324 Hume Hwy, Bankstown NSW 2200

BCA Assessment Report

15 December 2022

18662-BCA & Access-1

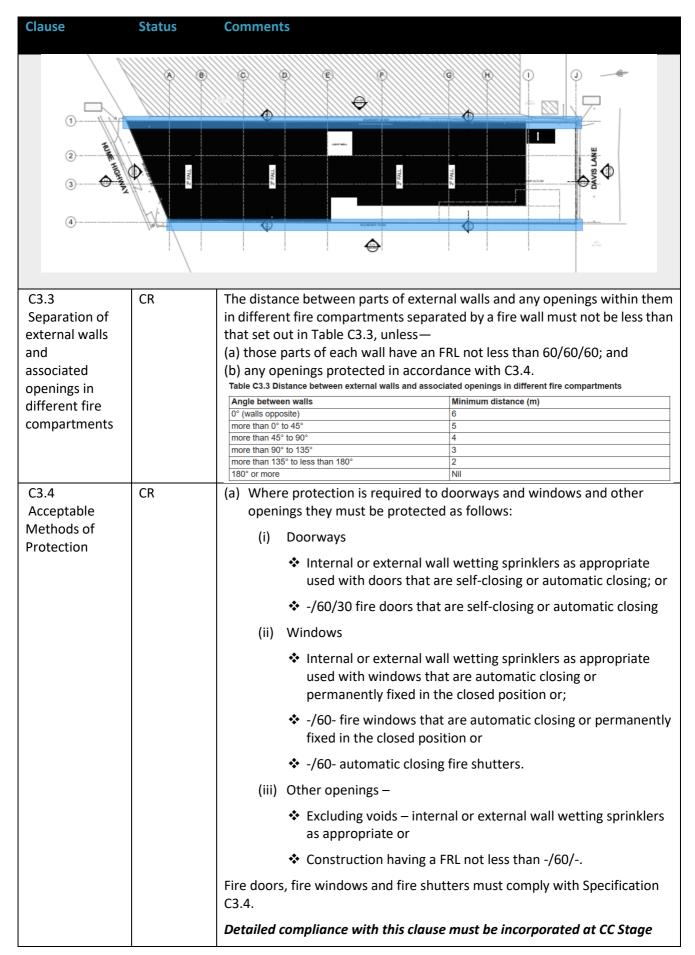
The potential fire *source features* to be considered for this building are the external wall of another building on the allotment which is not a Class 10 building, the side or rear of the allotment boundary or the far side of the road (blue);
